Docket Number:	07-AFC-06C
Project Title:	Carlsbad Energy Center - Compliance
TN #:	204016
Document Title:	Licensed CECP Exhibit 203, Staff Prehearing Conference (PHC) Statement, dated 1/14/2010
Description:	Includes Rebuttal Testimony. For Official Notice, Staff PHC Statement, received into evidence on 2/1/2010
Filer:	Mike Monasmith
Organization:	California Energy Commission
Submitter Role:	Commission Staff
Submission Date:	3/30/2015 8:41:56 PM
Docketed Date:	4/1/2015

STAFF'S PREHEARING CONFERENCE STATEMENT

Energy Commission Staff Rebuttal Testimony -- AIR QUALITY

Energy Commission Staff Rebuttal Testimony Regarding LAND USE

EXHIBIT VIS-1

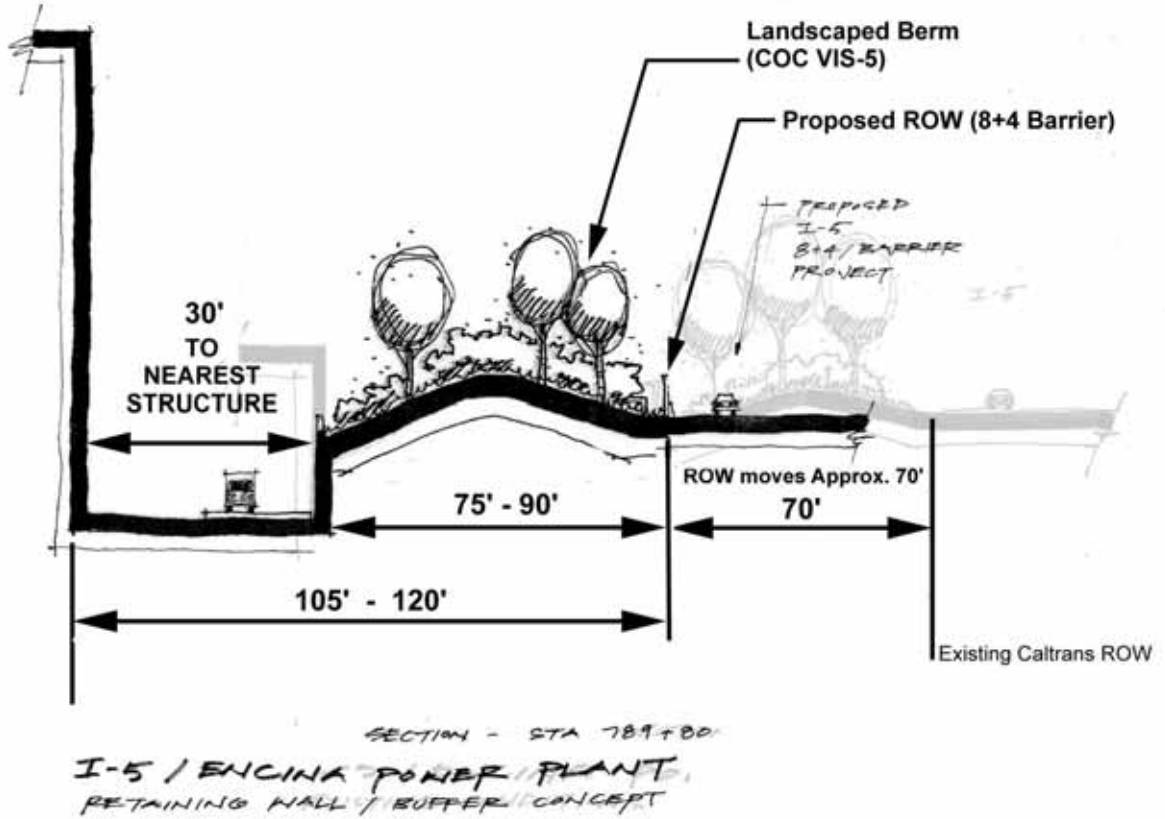
KOP 3. Mr. Neu asserts that insufficient room exists for tree screening of the east boundary of the CECP site. Staff's assumption that adequate room exists was based on in-the-field site surveying by CEC and Caltrans staff. Based on that survey, staff concluded that a berm and screening of similar height and magnitude to the existing would be possible, and that such screening would be sufficient to substantially screen the facility. Staff acknowledges that complete screening of the proposed stacks by this measure would not be possible from some viewpoints. However, in the context of staff's assessment method, invisibility of the project is not the determining threshold for impacts. Rather, staff's method requires that the facility be substantially screened, that is, to the point where the visible portions would be visually subordinate within the overall

view. Staff's cumulative conclusions are based on the belief that COC VIS-5 make this objective feasible.

EXHIBIT
WS/FP-3

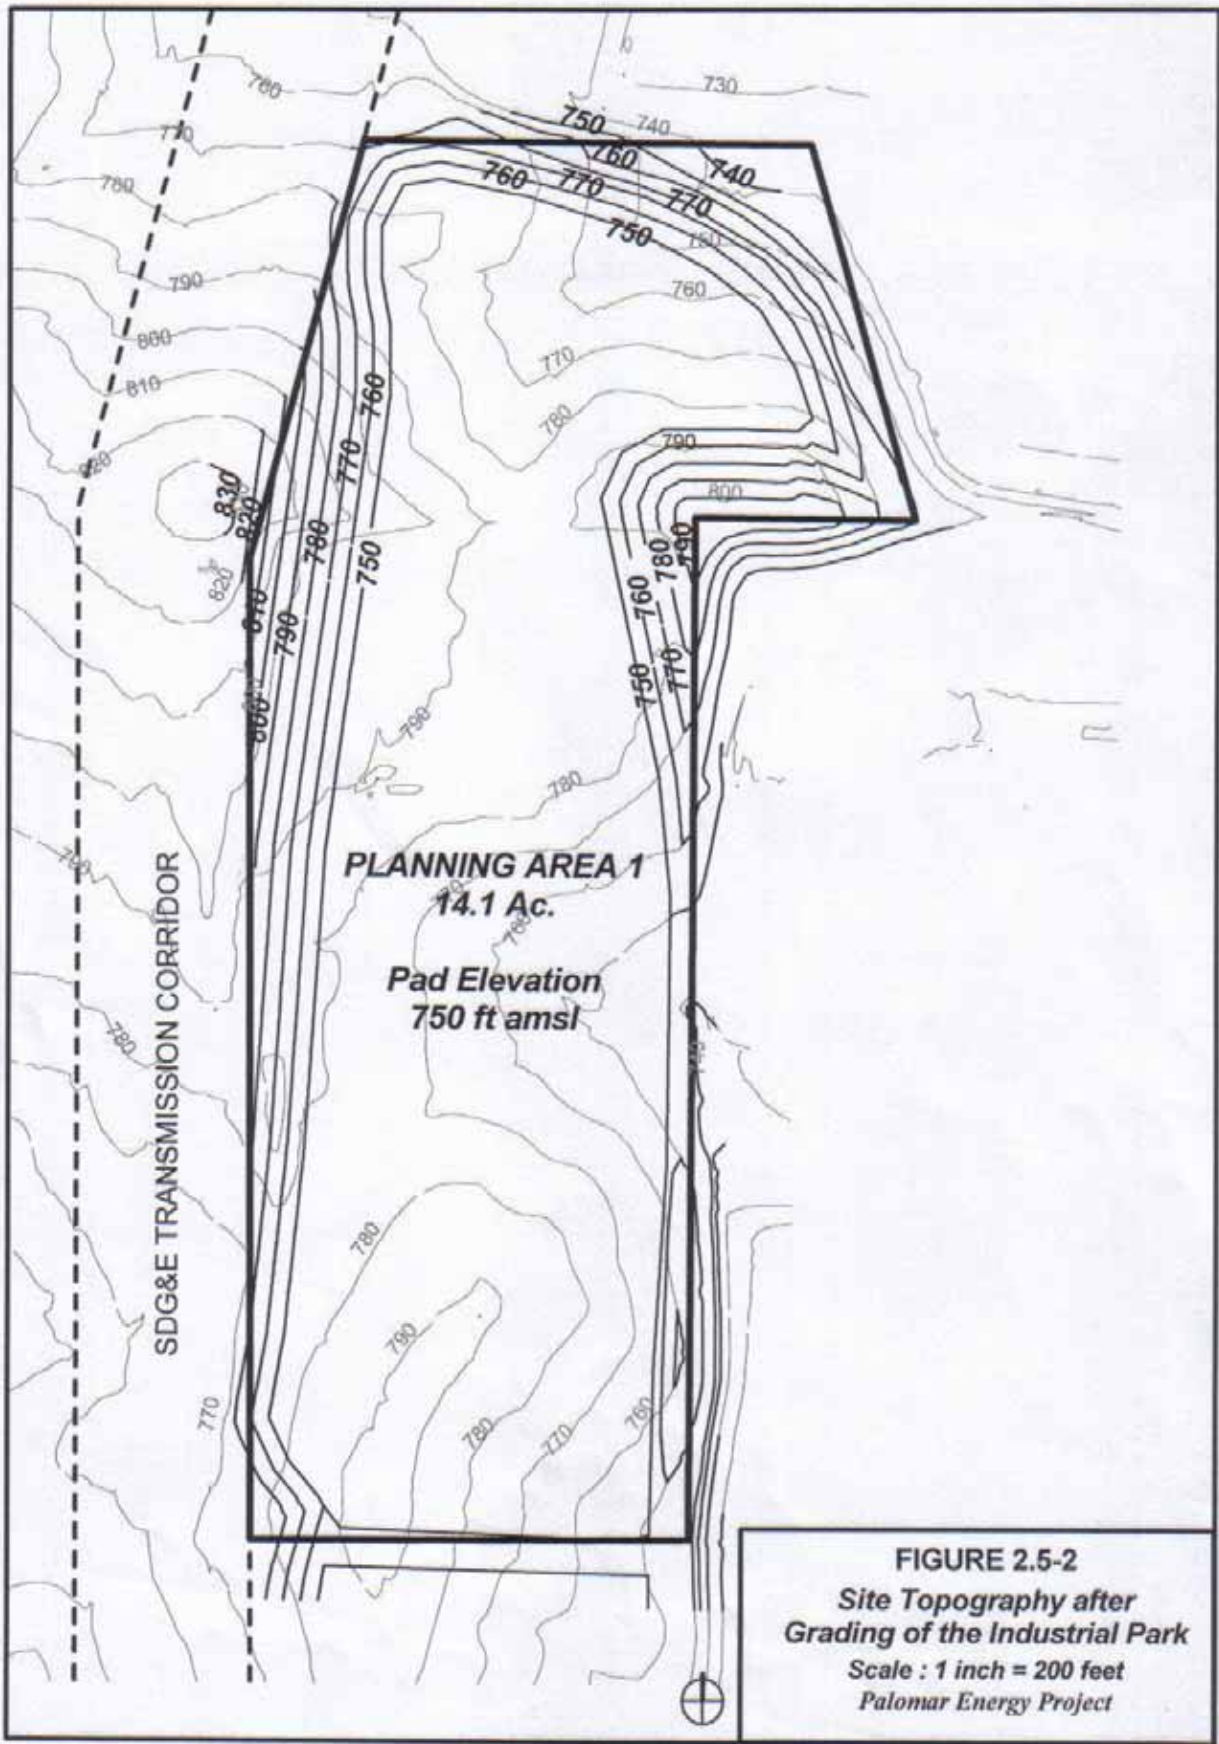
The power plant site most similar to the proposed CECP is the existing Palomar Power Plant in nearby Escondido (please see Exhibit WS/FP-2). I prepared the Worker Safety and Fire Protection, Hazardous Materials, and Public Health analyses for the Palomar project, conducted one HazMat, Worker Safety, Fire Protection, and Security audit at the site, and also conducted one additional site visit to investigate another matter. I have visited and walked around the site on several occasions and thus am very familiar with its dimensions and restricted access. Palomar is located in a “scooped-out” bowl, with steep (nearly vertical) rock/earth walls on the east and west sides and a lesser-sloped but still high wall on the north end. Only the south end is open at ground level and access at this end is severely restricted by the large cooling towers present. During the siting proceedings, I spoke with the City of Escondido Fire Department. Not once did they express concern about the limited site access and narrow width of the proposed and now existing fire access lane. A review of the plot-plan of the

Palomar Power Plant – along with those of the other four power plants I mentioned above - shows that all have fire lanes and restricted access points similar to or even more restrictive than that proposed for the CECP. In fact, the heights of the walls at the Palomar site are more than double the height of the walls at the CECP site. Furthermore, there is no “rim road” above the Palomar site. Moreover, regarding the CECP site, all but a small portion (<10%) of the “rim road” around the CECP site will remain intact and available for emergency response access.
